SUBMISSIONS REPORT

Maxwell Solar Farm

March 2020

Figure 1 Rehabilitation (Secondary) Domains within the proposed Solar Farm Project Boundary (yellow outline) overlaid on the Drayton Mine - Mining Operations Plan (AngloAmerican 2016).

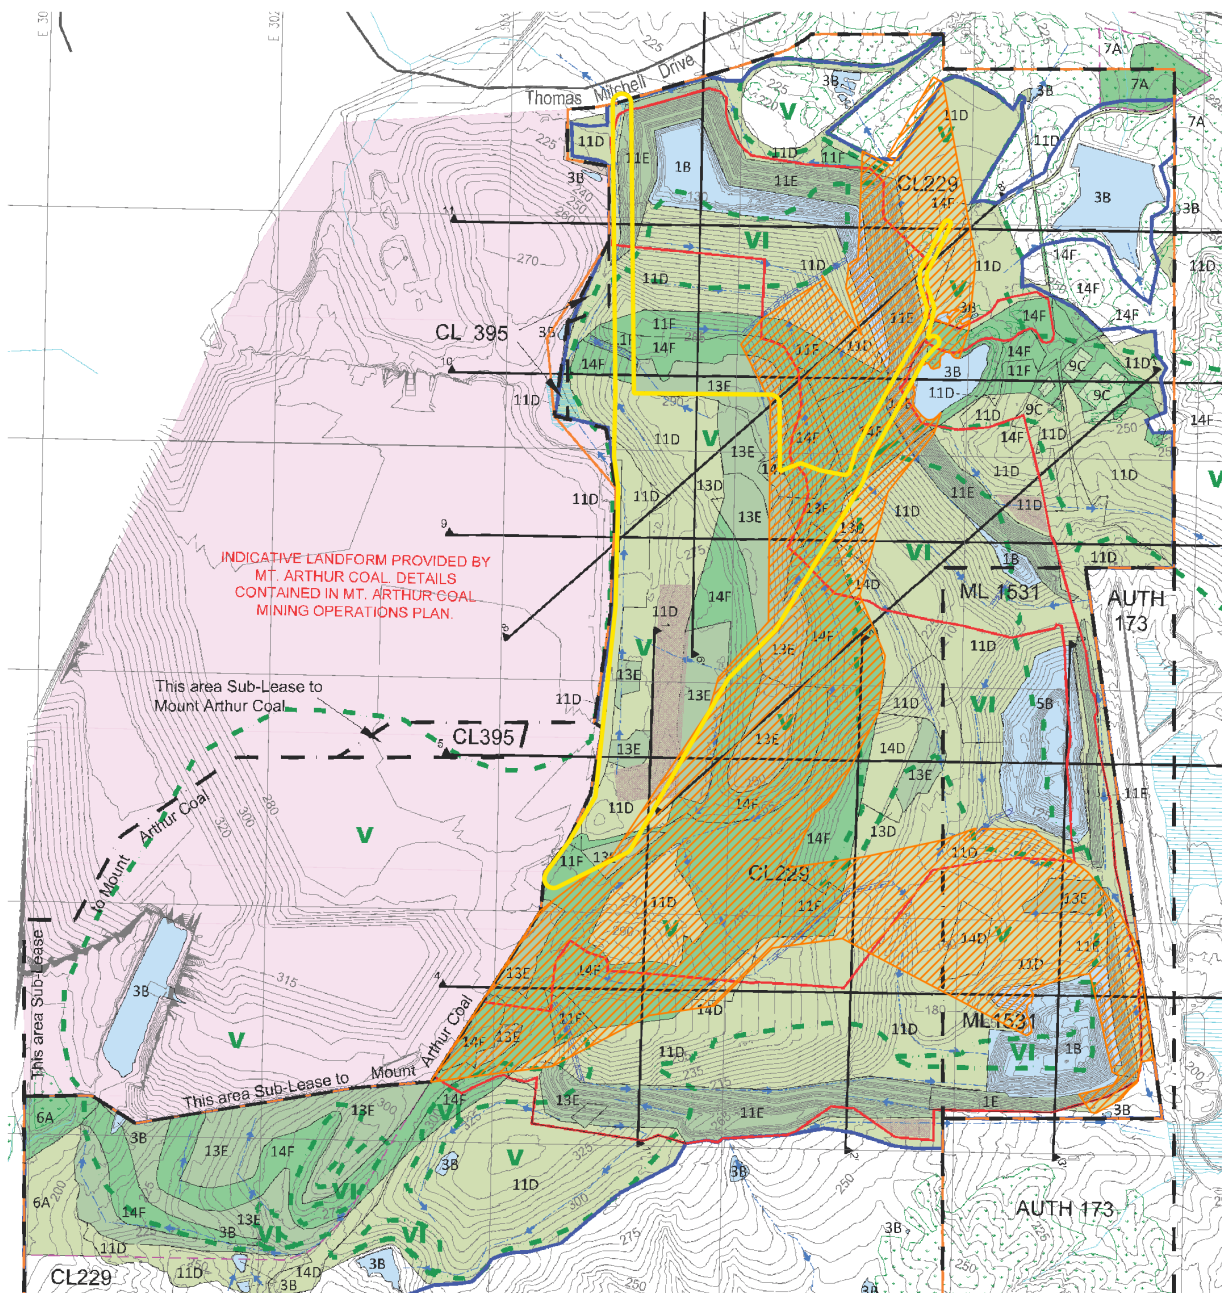
Issue	Detail of Issue	Proponent's Response
	<p>to rehabilitating much of this site as Trees over Grass (Primary Domains 12 and 13) and Woodland, with secondary domains woodland (E) and Forest (F). This should be used to guide the rehabilitation of the site post-Solar Farm, unless other uses with higher employment opportunities are approved for the site.</p>	<p>woodland and forest vegetation. The purpose of the woodland and forest vegetation is to link existing remnant woodland with suitable rehabilitation to provide corridors for the movement of fauna.</p> <p>It is proposed to rehabilitate the solar farm area to pasture vegetation (Class V) and a landscape able to support sustainable (low density) livestock grazing. The woodland and forest area would be re-positioned slightly to the east to maintain connectivity for fauna movement. This area already contains some woodland and is the focus of current tree planting programs.</p> <p>A change to the woodland corridor was made during 2017 to adjust areas between the post mining land uses of grazing and native woodland. This was done in recognition of the woodland areas being more suited to the steeper slopes and the flatter areas more suited to grazing with greater potential for agriculture. This change was accepted by DPIE to be generally consistent with the conditions of consent and provided a net increase in suitable habitat for native fauna (refer Appendix C).</p>

Figure 2 Topography of proposed Solar Farm within the Project Boundary (yellow outline).

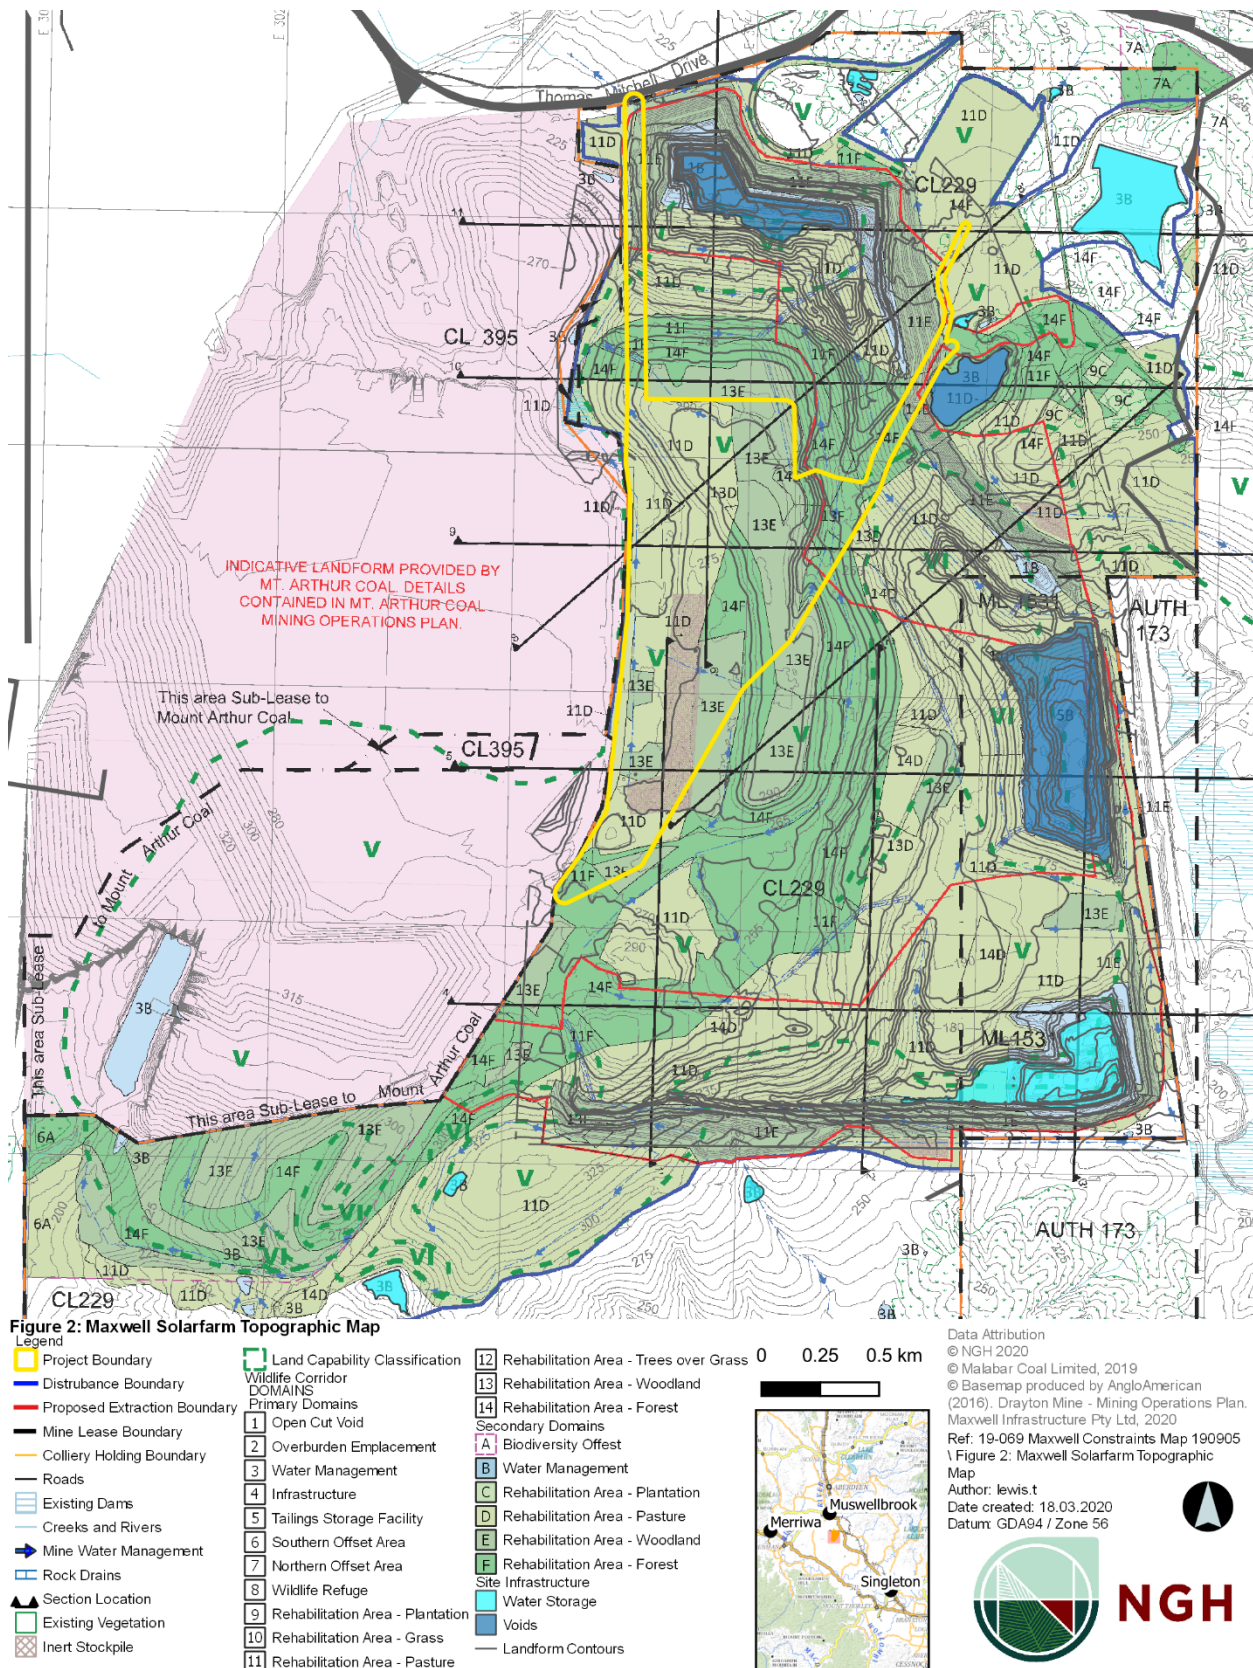
<p>Site Topography</p>	<p>The Mine Closure Plan and rehab activities for the former Drayton Mine site generally do not include micro-relief, which has resulted in landforms that are unnatural in appearance. Future rehab of the Solar Farm site should be encouraged to alter the land surface to incorporate micro relief.</p>	<p>Maxwell Solar is committed to minimal ground disturbance and the retention of ground cover. Altering the topography of the proposed solar farm site would involve site-wide ground disturbance and is unnecessary for the installation and effective operation of the proposed solar farm. Altering the topography of the proposed solar farm site would result in potential for soil erosion.</p> <p>The proposed site has a natural appearance, having been rehabilitated, containing two plateaus separated by a ridgeline with undulating landscapes.</p>
